PROJECT: Westcliff Pines 2

SUBMITTAL: 1st

CITY OF LAS VEGAS		DATE:
INTER-OFFICE MEMORANDUM		February 23, 2012
TO: Land Development Services Department of Public Works		FROM: Albert Sung, P.E. Flood Control Project Engineer Department of Public Works
SUBJECT:	Drainage Study for: Westcliff Pines 2	COPIES TO: L.R. Nelson Consulting Engineers
Cross Streets:	SEQ of Summerlin Pkwy. & Durango Drive	HAND Property Holding Company
File Number:	F:\Depot\DSMemos\DS4550A.doc	Bart Anderson, P.E., DevCo
Parcel Number:	138-28-401-015	
Zoning Action:	SDR-44166	
FEMA Flood Zone	YES NO X	
Proposed Storm Drain	YES NO X

DRAWN BY: Feb. '12
DESIGNED BY: Feb. '12
CHECKED BY: Feb. '12
PROJECT NO.: N/A
SCALE: N/A
SHEET
DT1
6 OF 16 SHEETS
CLV DRAWING NO.

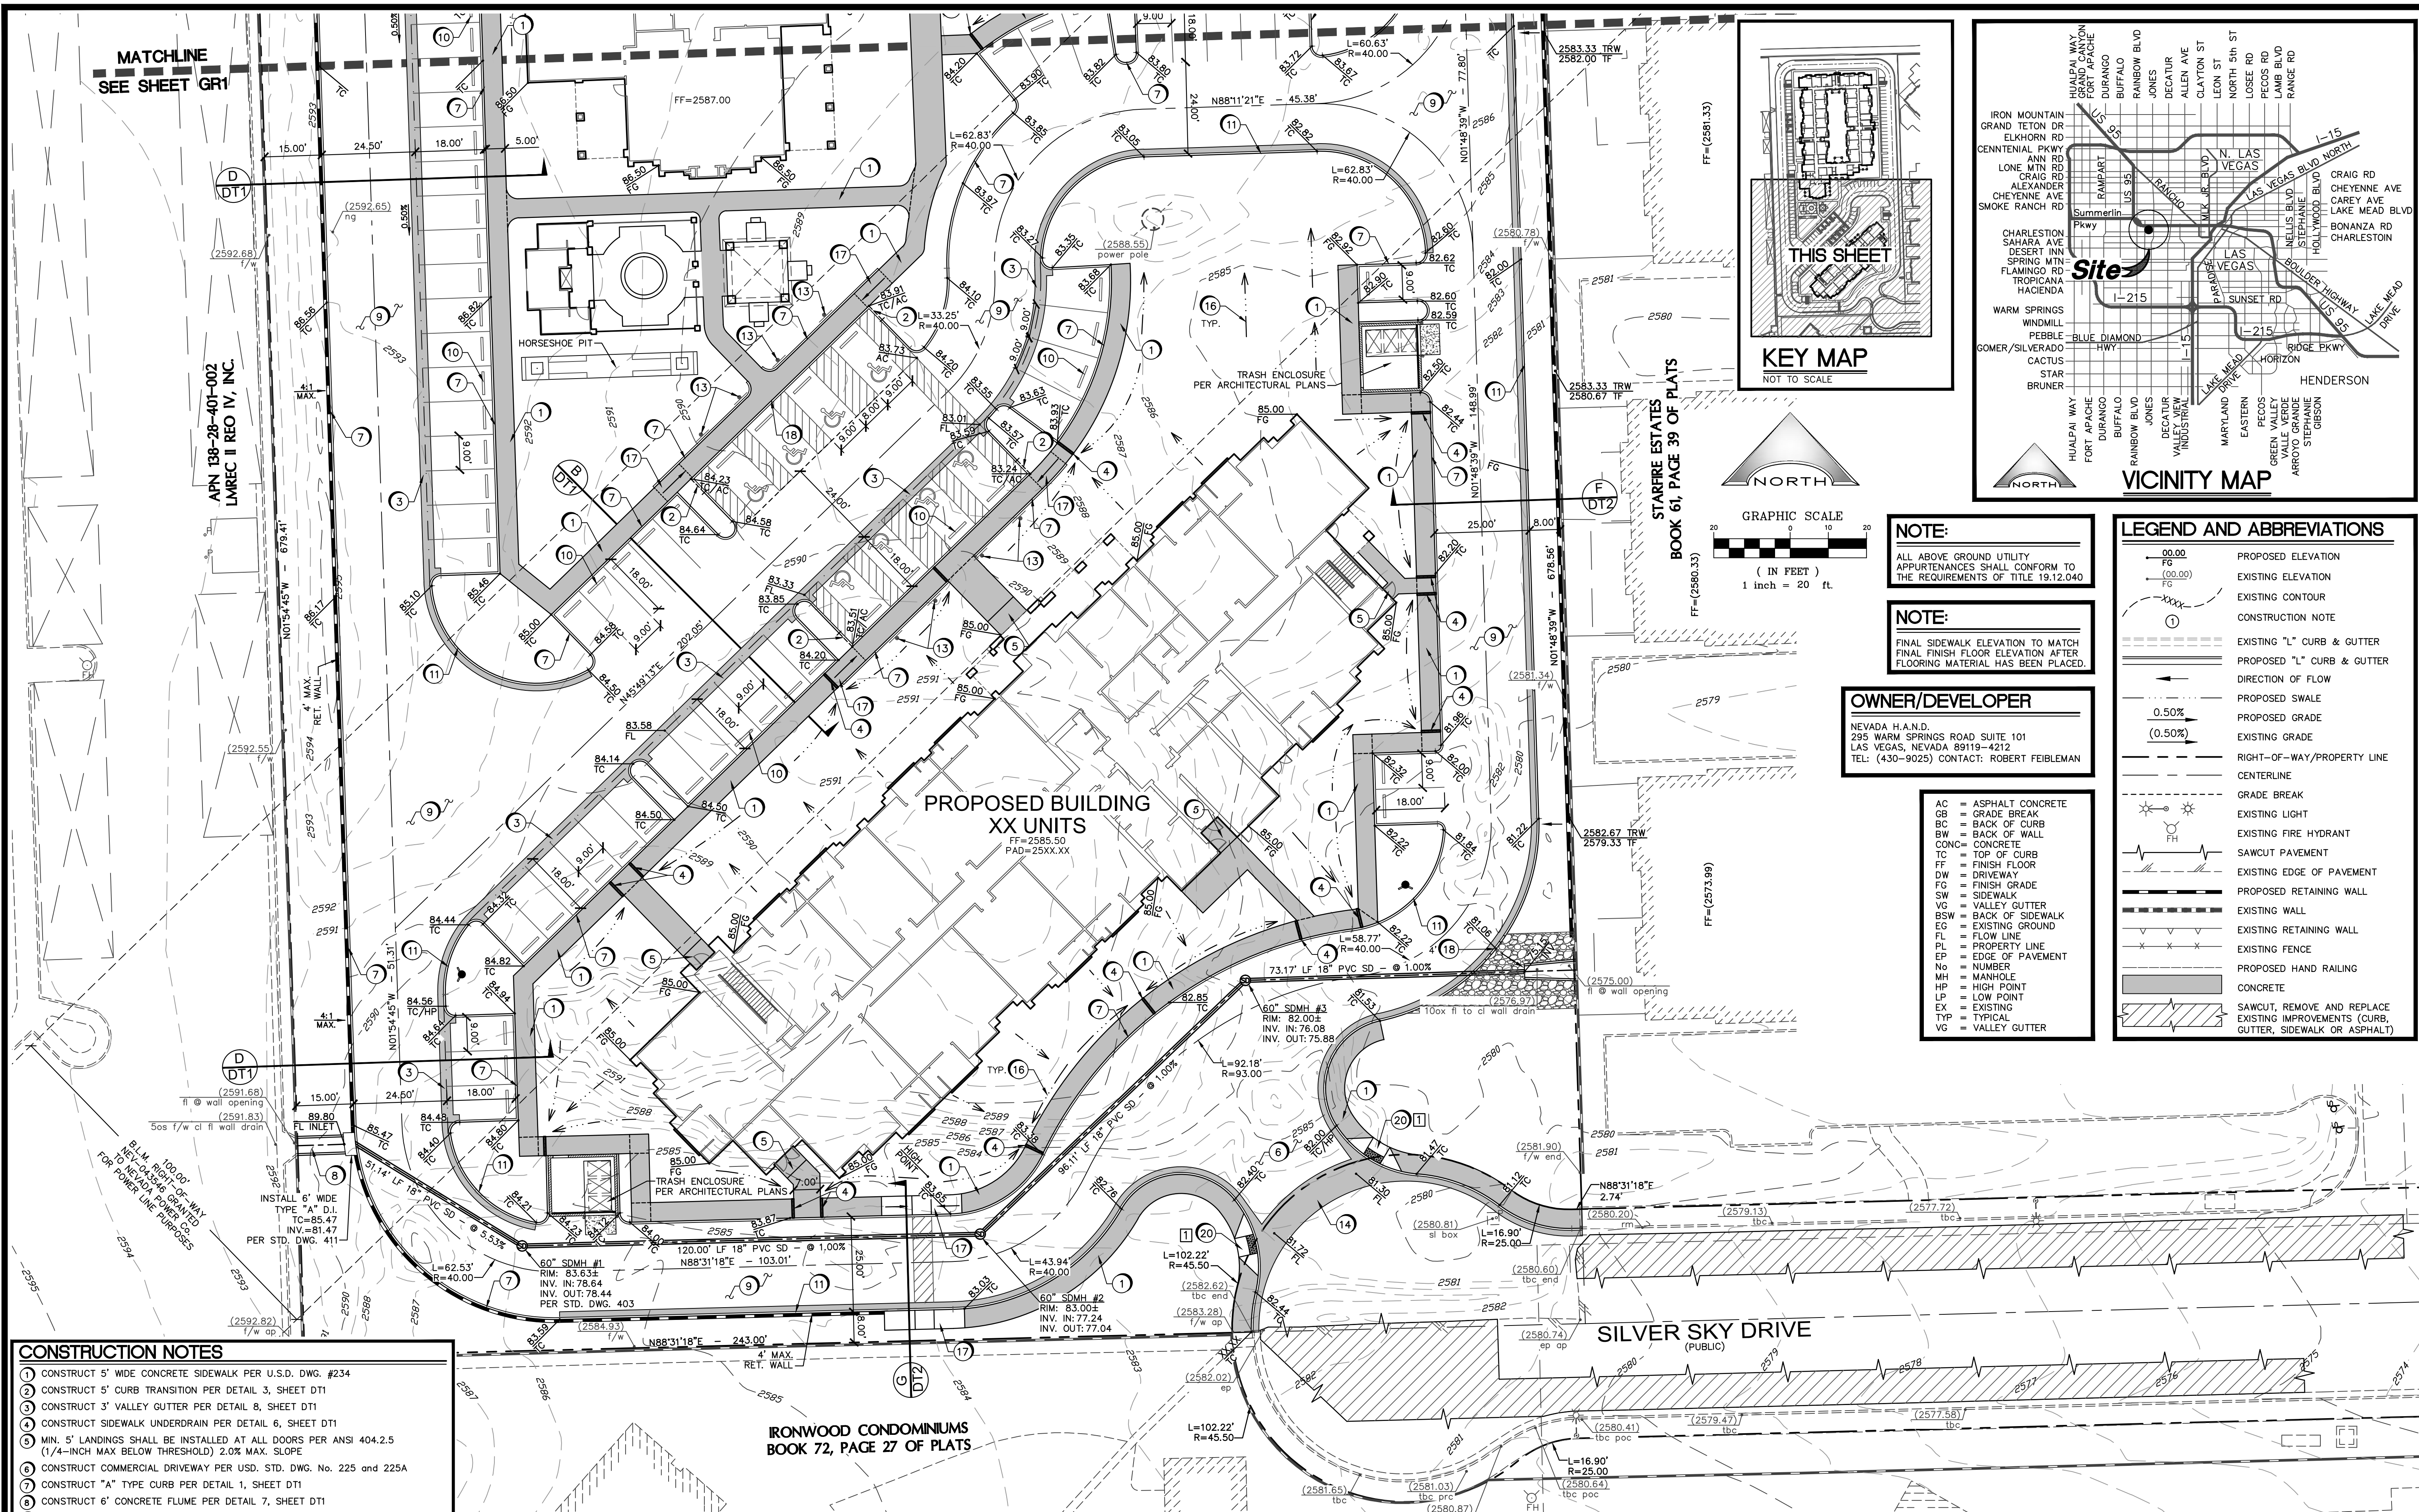
12. **Sheet SD1:** As stated in Comment #8, provide a connection detail in the plan view and the profile section.
13. **Sheet DT1:** Detail Section B is to be found nowhere on the grading plans. Identify Detail Section B accordingly.

14. **Sheet DT1:** On Detail Sections C and D, provide a swale (minimum 6"-deep) behind the proposed retaining wall, leave a minimum 1'-bench at the top of the wall.
